Sea Link

Volume 9: Examination Submissions

Document 9.134: Applicant's Comments on Other Submissions Received at Deadline 4 and Deadline 5

Planning Inspectorate Reference: EN020026

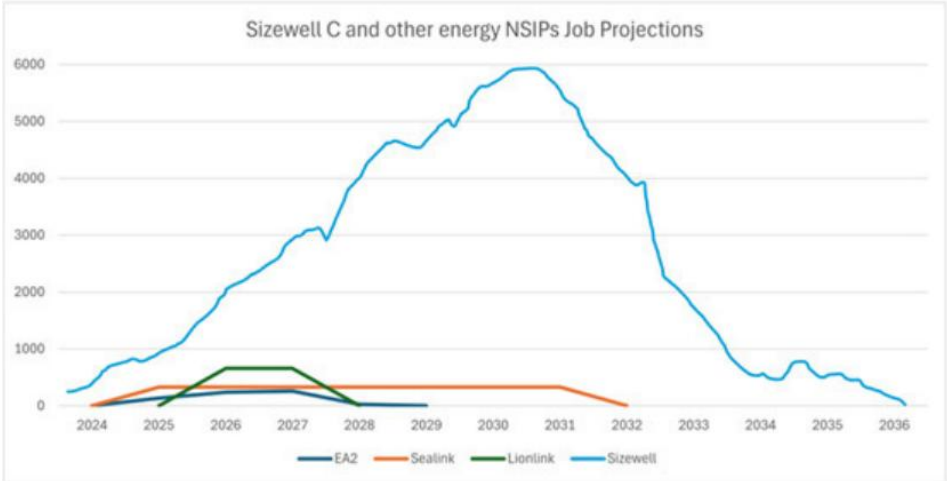
Network Rail (NR) in its response to ExQ1 (REP3-095) stated in relation to the railway that <i>‘Any such closure would be essential to ensure safe access for investigations of the bridge, installation of a mini-bridge (if it oversails the railway) and any required bridge strengthening works. Further, any activities within 10 meters of the NR boundary fence and over the railway corridor would necessitate possession of the railway lines, thus leading to their closure during the works. These closures would pose a clear detriment to safe and efficient running of the railway, as well as potential service impacts.’</i> In ESCEP’s opinion this statement would indicate that for each placement and installation of the temporary overbridge (referred to as a minibridge) closure/possession of the line would be essential during the period the temporary overbridge is in place over the current Benhall bridge as it is, in essence, oversailing the railway and activity over the railway corridor, and	The Applicant has and continues to liaise with Network Rail on the works at Benhall Rail Bridge. The Applicant understands that should the mini-bridge need to be lifted directly over the railway then a closure of that railway during installation would be required. However, if the mini-bridge is installed within the confines of the highway bridge, eliminating the risk of falling objects landing on the rail infrastructure, then a closure would not be required. Any method statement for undertaking the works to install, use and remove the bridge would be developed in full consultation with Network Rail to alleviate any concerns they may have. Any closures or track access required to inspect, survey or repair the bridge shall be agreed with Network Rail and shall be programmed to limit disruption to their customers.

the period of lifting and/or assembling/dismantling of the temporary bridge or its component parts and mounting such on a vehicle to transport to the storage compound as that is activity over the railway corridor or within 10m of the NR railway fence. It is clear NR has concerns about the impact of closures and possessions on rail services, be they passenger or freight services.	
Alternative rail route	Whilst the repair of the current bridge would almost inevitably require a longer period of closure than a single temporary overbridge use, frequent repeated overbridge operations would have a considerably greater impact on services, as well as the local population. There is no alternative rail route for passenger traffic south of Oulton Broad and lengthy bus replacement is the alternative currently used for closures. Access by freight traffic from north of Saxmundham would be complex with reversal of travel at Saxmundham and Lowestoft/Oulton Broad. Additionally, that line, its crossings and structures have not been upgraded to meet the requirements of Sizewell C freight traffic. ESCEP considers the Applicant should thus be required to either agree to undertake any, and all, work required to upgrade the Benhall Bridge to allow passage of all AIL loads over it without a temporary bridge or to seek an alternative route for AIL loads into the Sea Link and LionLink sites, for both construction and operation, avoiding passage over the Benhall Bridge. ESCEP acknowledges the latter is likely to result in a longer route into the site but it considers the ExA and Applicant must provide a solution that make all reasonable efforts to minimise substantive and prolonged adverse impact on the local community and those using key services in Saxmundham	The vast majority of construction traffic can use the Benhall Rail Bridge and the proposed construction access with no mitigation required at the bridge, as the vast majority of construction vehicles will be less than 46T. A limited number of Abnormal Indivisible Loads (AILs) are required to access the Converter Station construction site and should these vehicles be routed over the Benhall Rail Bridge mitigation would be required for these limited movements. The Applicant has produced the Application Document 9.112 (A) Benhall Railway Bridge - Crossing Feasibility Study [REP4-101], that outlines the options under consideration and identifies that remedial works to the bridge is the preferred option.

Figure 1. HGV Daily Volumes by Project on Selected Road Network Points

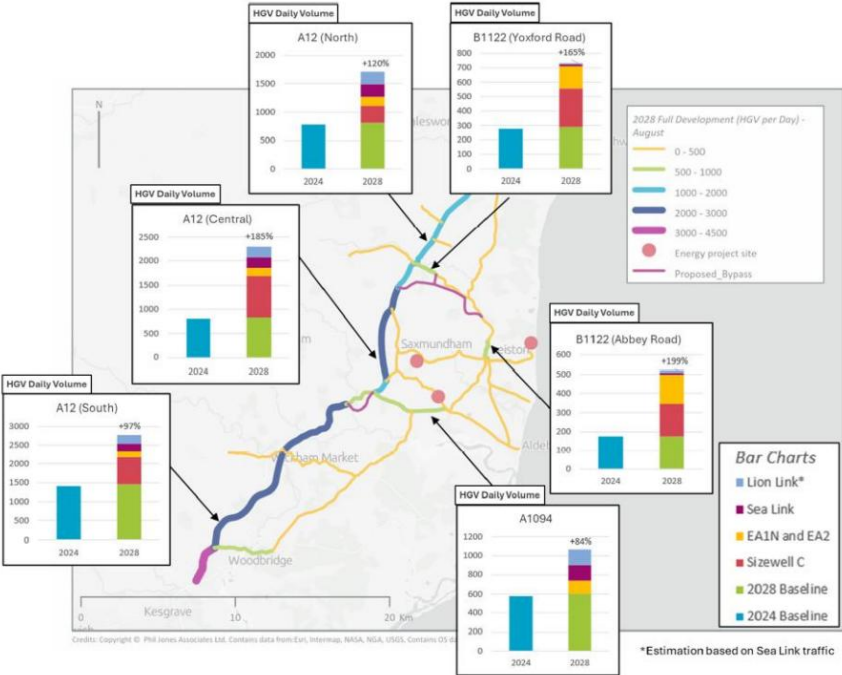
Reference	Matter	Point Raised	Applicant's Comments
		 In Figure 1 above, for the area labelled as A12 (South) the indication is that there will be at least 1,000 daily HGV movements through Marlesford if all projects (including an estimate for LionLink) are taken together. This represents a near doubling of the number of HGVs currently passing through the village. The Applicant's project is likely to contribute at least 300 of these additional movements. It is inconceivable that this level of increase will not adversely impact the 23 dwellings in Marlesford that are within 20m of the A12 carriageway. We contend that the Applicant's project will increase levels of anxiety and will add to the feelings of fear and intimidation already experienced by our residents – particularly when walking beside the A12 or when crossing it. We argue that the Applicant has failed to properly carry out its surveys by not using data from non-neutral months. It appears that the Applicant's surveys were carried out in January and February of 2024. It is estimated that total traffic volumes in these months are between 5-10% lower than in typical neutral months. In addition, the Applicant appears not to have allowed for the considerable increase in summer months' traffic which can be up to 25% greater than a typical neutral month, nor does it appear to take into account the considerable and slow-moving agricultural traffic at certain times of the year. We would urge the ExA to require the Applicant to re-do their traffic surveys in neutral months, or re-base their data for neutral months using currently available SCC data.	response to the ExA's s89(3) letter of 5 September 2025 - 9.18 s89 (3) 16 September Covering Letter [AS-106] and in relation to the SEAS Traffic/Transport Relevant Representation within Table 2.57 of Application Document 9.34.1 (B) Applicant's Detailed Responses to the Relevant Representations identified by the ExA [REP2-014].

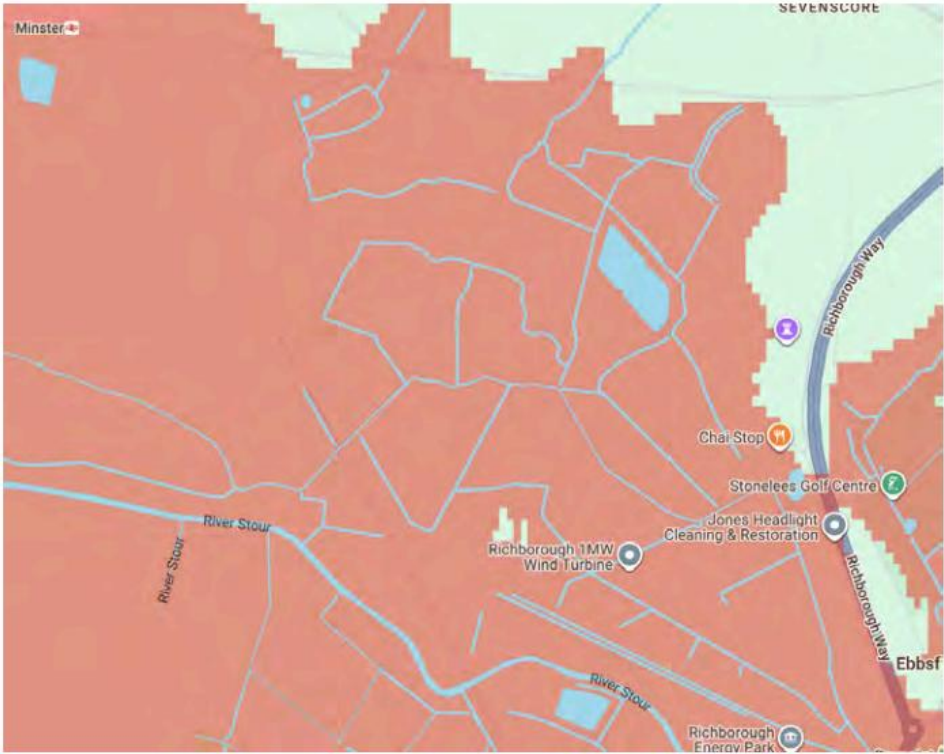
Looking towards the converter site from near the Railway line shows the extent of the flooding near the pylon route (photos taken 4th February 2026).

Below are 4 images from 2023. This is not a new occurrence. These fields flood every year. It is why it's called a marsh. The ability of this land to act as a sponge to prevent widespread flooding is vital. Removing that from the area needs to be properly modelled, not scoped out.

Reference	Matter	Point Raised	Applicant's Comments
		 We have also provided modelled data mapping from Climate Central and would therefore urge you to challenge the data on which the Kent onshore location is pushing ahead in this location despite the clearly unsuitable conditions and the risks of further flooding.	
	Roll back on SuDS provision for adjacent site	This matter relates not only to Cumulative Impact, but also to SuDS plans that were made for the adjacent site and then reneged upon because of the geology/hydrology. Please refer to Thanet District Council applications for the adjacent BESS plant site as follows:- <i>Application F/TH/20/1467 Application for approval of Condition 6 (Verification Report) attached to Planning Permission F/TH/20/1467 for the development of an electrical battery storage facility with 49.9MW capacity including the installation of 23 batteries, electrical plant and equipment, alterations to land levels, landscaping and associated works:</i> <i>Flood Risk Assessment Document in F/TH/20/1467 4.4 SUDs were ruled out due to shallow ground water 4.5 Therefore propose to discharge surface water into the River Stour to the SW of the site 4.9 Run off from road collected in channel drains and conveyed to existing outflow. An attenuation tank will provide sufficient storage to prevent flooding 4.10 Construct inspection chambers as catchpits to trap and retain suspended solids.</i> The upshot of this is that SuDS were promised and cannot be delivered in this location. This site is already proposing to discharge straight into the River Stour! In addition, the fire risk from the BESS plant is particularly high and fire risk management is on record as a concern for Kent Fire and Rescue. Fire retardant pollution will be washed straight into the River Stour in the event of a fire. This will be true also for the Converter and SubStation site.	The Applicant clarifies that there are a wide range of available SuDS techniques, some of which rely on infiltration drainage and others that provide for the collection, storage and attenuation of rainfall runoff in above ground features such as ponds and basins, to facilitate an attenuated discharge into a watercourse. Infiltration based SuDS are not proposed to serve the Kent Onshore Scheme, as these would be unviable due to prevailing ground conditions. Instead, provision for above ground SuDS features is included, which provide sufficient volumes of storage for rainfall runoff from the proposed development area to attenuate storm flows from the 1% annual chance event, inclusive of an allowance for climate change. Discharges from these features would be restricted to rates agreed with the Stour (Kent) Internal Drainage Board. Penstock valves will be installed to isolate the outfalls of the drainage systems serving the operational substations and converter stations to prevent a pollution incident in the unplanned event of a fire. The valves will be designed to close automatically, with a manual override available in the event of automation failure and the systems would be suitably maintained over the operational lifetime of the Project.
